A G E N D A
FARRAGUT MUNICIPAL PLANNING COMMISSION

December 18, 2014
7:00 p.m. Farragut Town Hall

**SUBJECT: STAFF COMMENTS ON THE SITE PLAN FOR PARKING LOT
MODIFICATIONS AT THE FARRAGUT VILLAGE AT 609 N.
CAMPBELL STATION ROAD**

SUBJECT: STAFF COMMENTS ON THE SITE PLAN FOR DRAINAGE MODIFICATIONS ASSOCIATED WITH PARCELS 1.00, 1.01 AND 1.02, TAX MAP 152-C, SOUTHWEST CORNER OF KINGSTON PIKE AND CHAHO ROAD

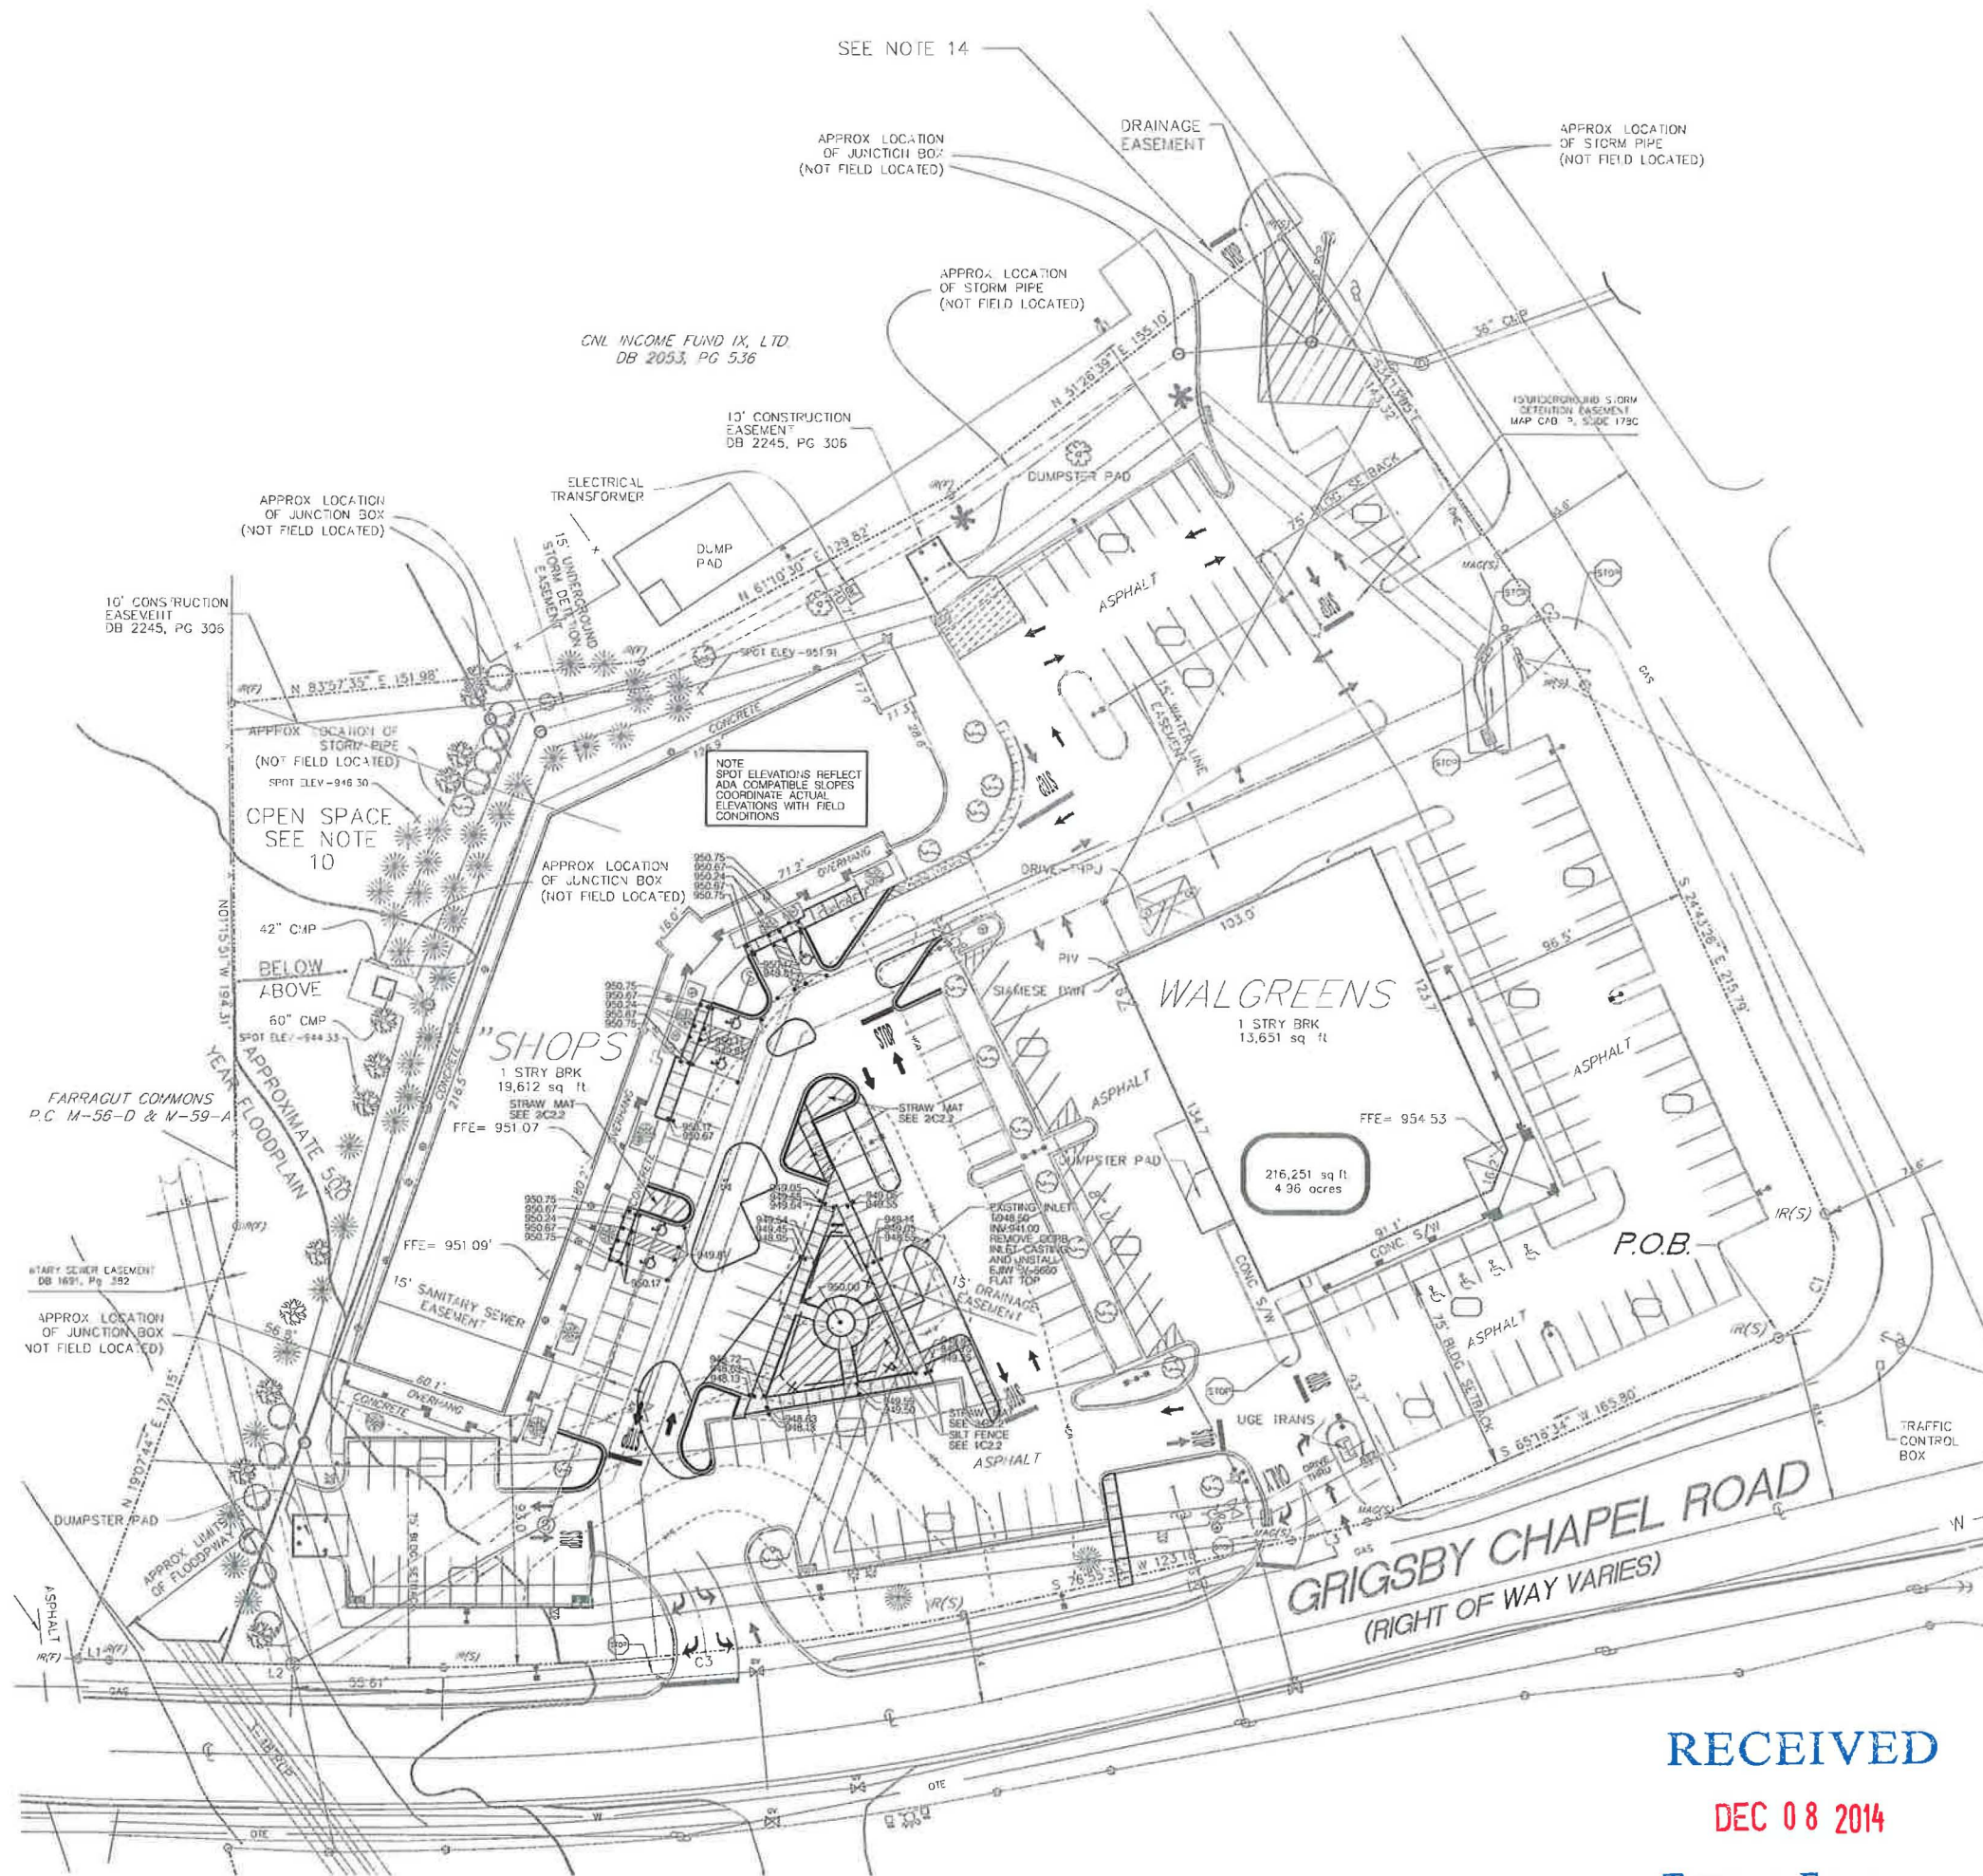
1) Please verify fire lane placement and include a detail (if a new fire lane is proposed);

- 2) Please number sheets 1 of..., 2 of...;
- 3) Please include the developer's address and telephone number;
- 4) Please have the qualified preparer seal and sign the plan;
- 5) Please include the acreage of the property and all property reference information on the proposed site plan;
- 6) Please include in a table the required number of parking spaces, including handicap spaces, and the number of regular and handicap spaces being provided;

- 7) Please provide four (4) bicycle parking spaces. This could be two inverted "U" shaped racks with a concrete pad. Please include a location and detail for this;

- 8) Please ensure that any modified interior and terminal islands are at least five (5) feet in width (as measured from back of curb to back of curb) throughout their entire depth. Based on the plan submitted, this will likely result in the loss of at least one parking space;

- 9) If a fountain is proposed please provide details. Staff would suggest considering a landscaped rain garden in this area;
- 10) If any new or modified site lighting is proposed, please submit a site lighting plan to verify compliance with the Town's outdoor site lighting requirements in the zoning ordinance;

- 11) Please reflect the utilities and established easements on the proposed plan where improvements to the site are proposed (there is a drainage easement and a sanitary sewer easement that could be impacted);

- 12) Please show existing sidewalks and provide a sidewalk connection between the parking lot and the sidewalk along Grigsby Chapel Road;
- 13) Please show the proposed handicap parking spaces and include a detail for these to verify compliance with all applicable requirements;

- 14) Please verify lot coverage. Will this plan increase the existing lot coverage?
- 15) Please show the extent of parking lot demolition and how this will tie into the undisturbed portion of the parking lot. For visual interest and stormwater benefits have you considered using permeable pavers in the area where the parking lot is being modified?

- 16) Will any existing businesses in this center be closed temporarily as a result of this work?
- 17) Please submit a landscape plan for the parking area renovation and verify compliance with shade tree requirements and the landscaping required between the building and parking lot;

SITE GRADING, DRAINAGE & EROSION CONTROL PLAN

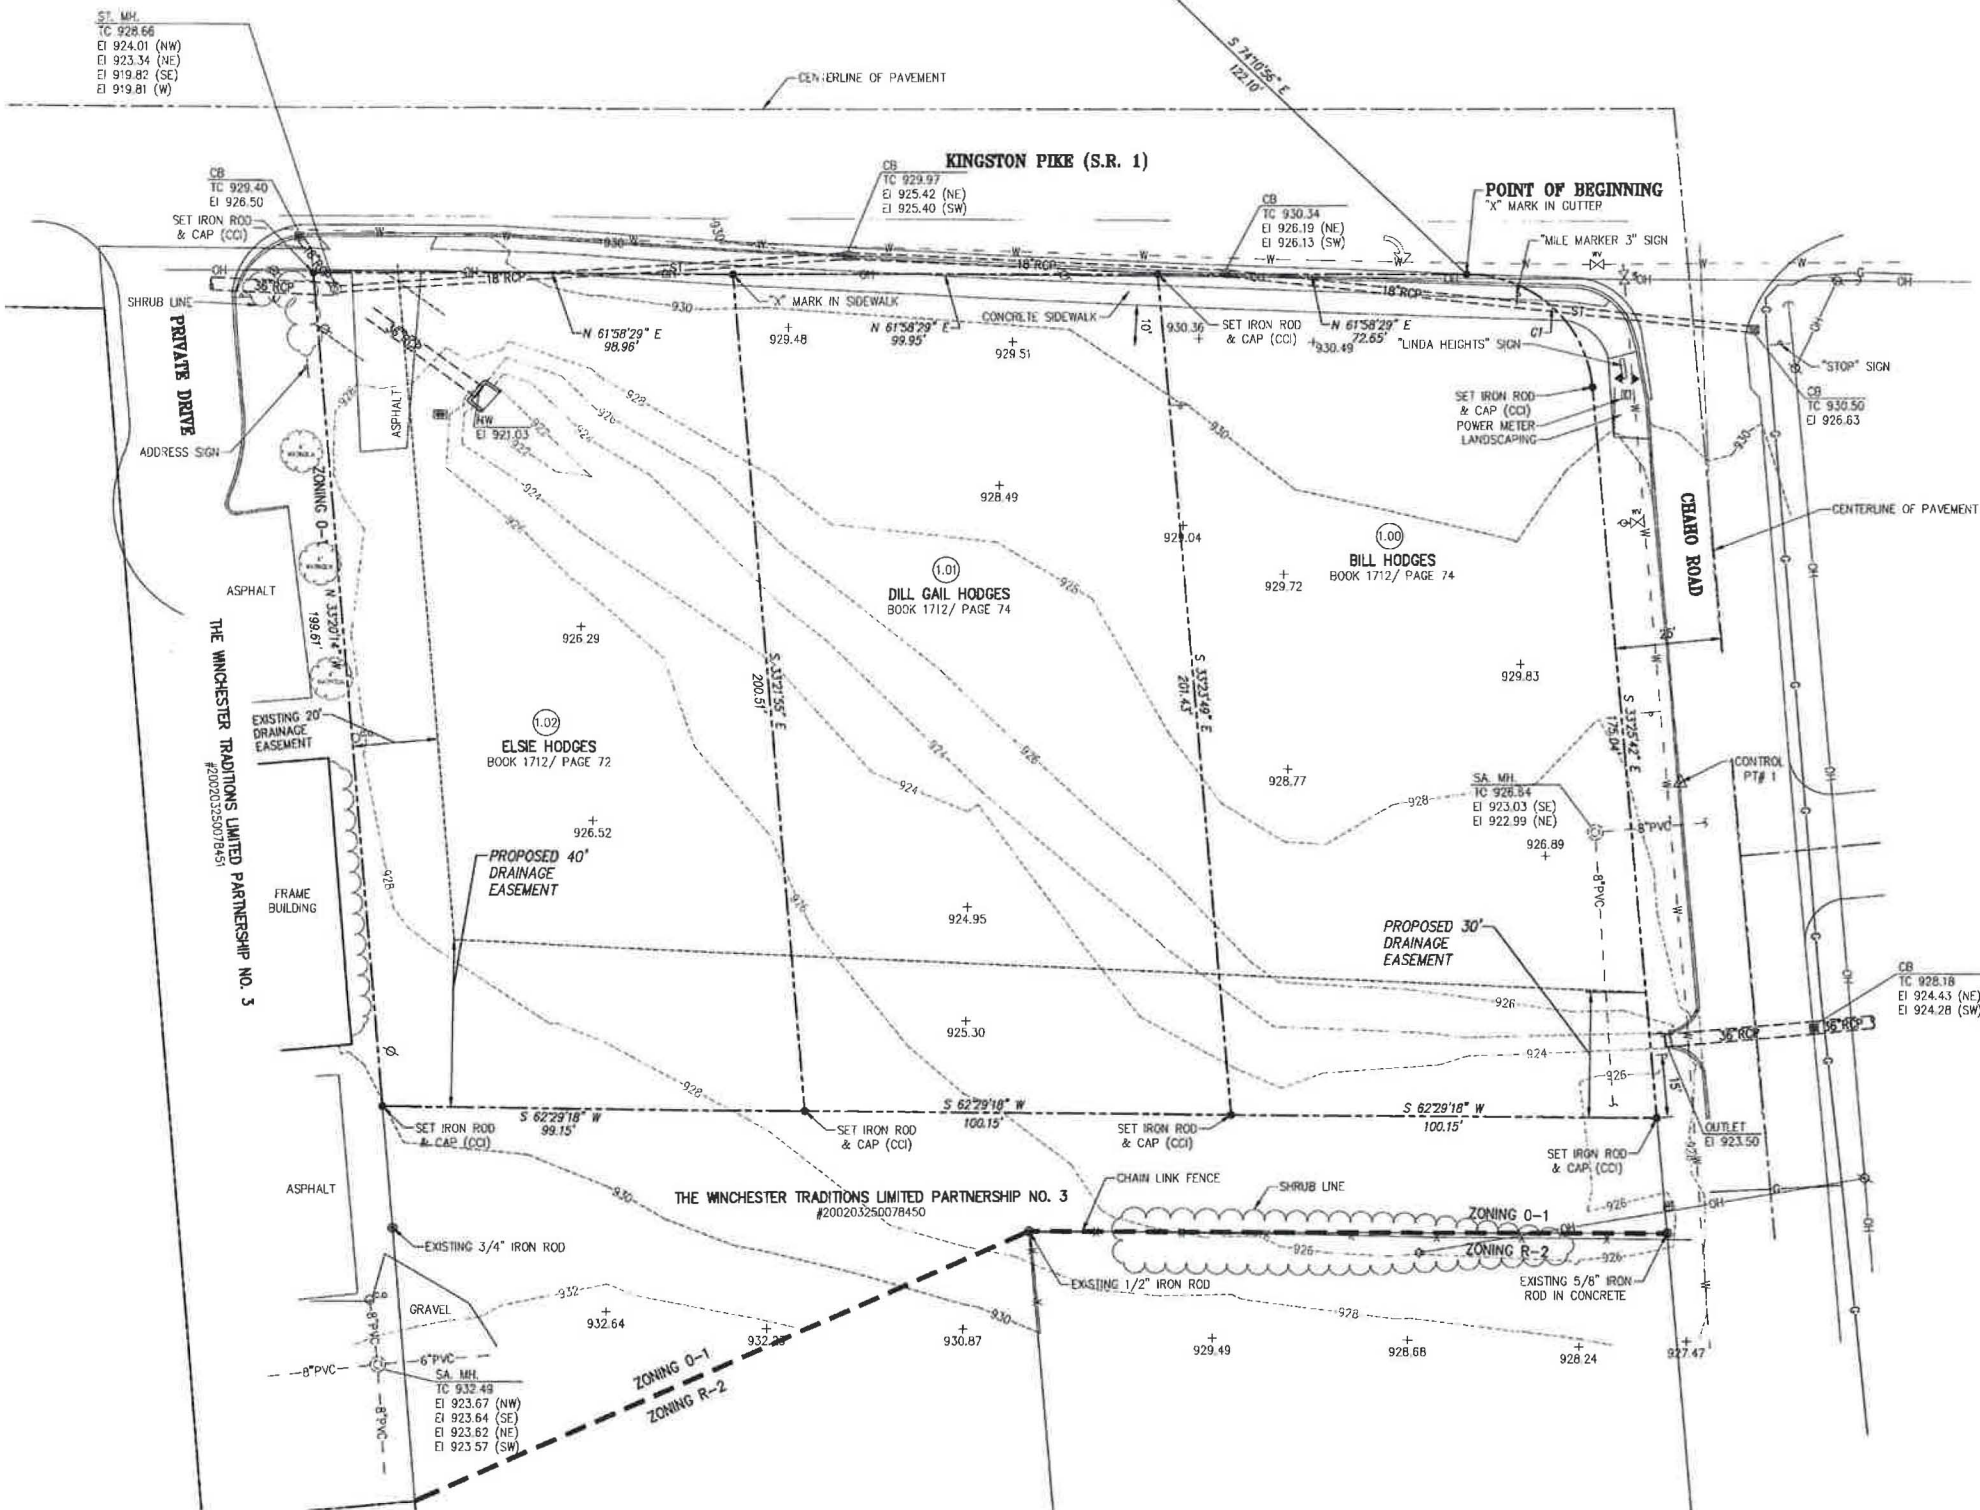
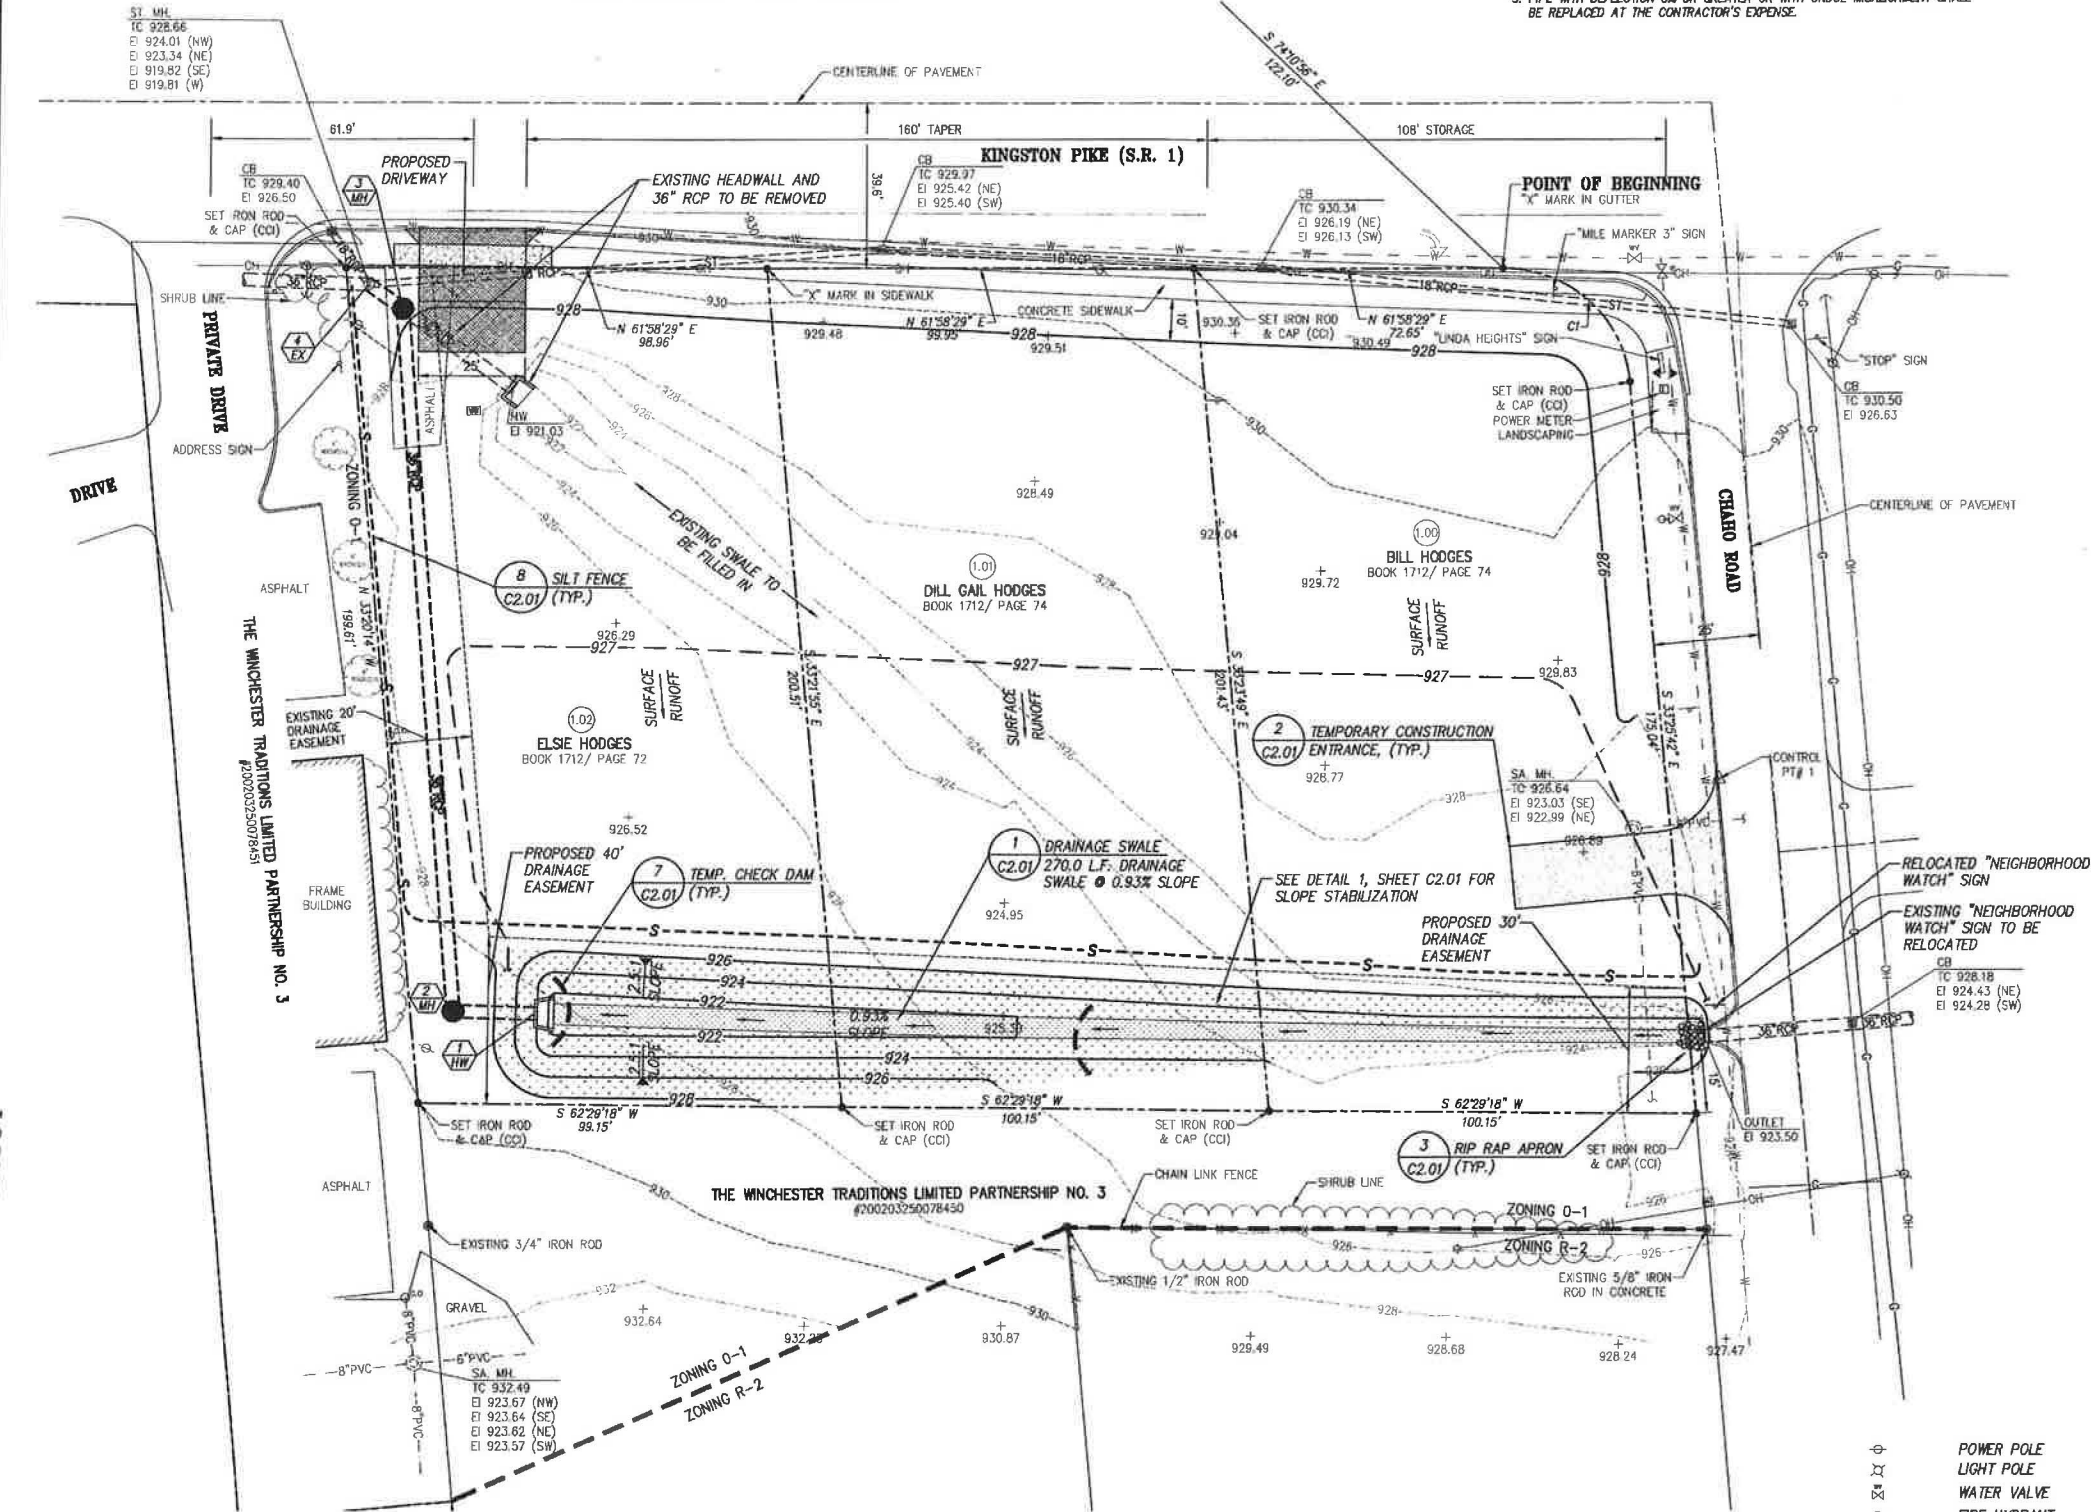
- 1) Please number sheets 1 of..., 2 of...;
- 2) Concrete low flow channels and slopes steeper than 2.5:1 are not permitted. Please revise. Rip rapped drainageways are strongly discouraged (they are expensive, challenging to maintain, do not provide for adequate infiltration since they are lined, and are unsightly). Staff would recommend a bioswale with dissipation measures incorporated into the design. Please coordinate the landscaping with the planning division;
- 3) A plat will be needed once drainage and grading work approved by the Town is complete. This plat will provide for any modified easements and required right of way per the subdivision regulations;

- 4) Since this is a site plan associated with drainage improvements please remove reference to a proposed driveway. Only the construction entrance access should be shown on these plans since it is required in association with the drainage improvements. The construction entrance access is correct in the location proposed;
- 5) Please coordinate with the Town Attorney on how this proposal should be addressed as it relates to the stipulations provided for in the existing drainage easement as recorded in Deed Book 1771/Page 994;

- 6) The grading plan indicates that the existing swale is to be filled. Please show proposed contours, which will show limits of construction. As property currently drains to the diagonal swale and to the northwest, how will the property drain once grading is complete?

- 8) An erosion control letter of credit will be required prior to the issuance of a grading permit. The amount will be determined by the Town Engineer based on the finalized grading plan;

DRIVEWAY ADDITION	12-08-14
REMOVED PER TOWN OF FARRAGUT	12-08-14
REVISIONS	DATE
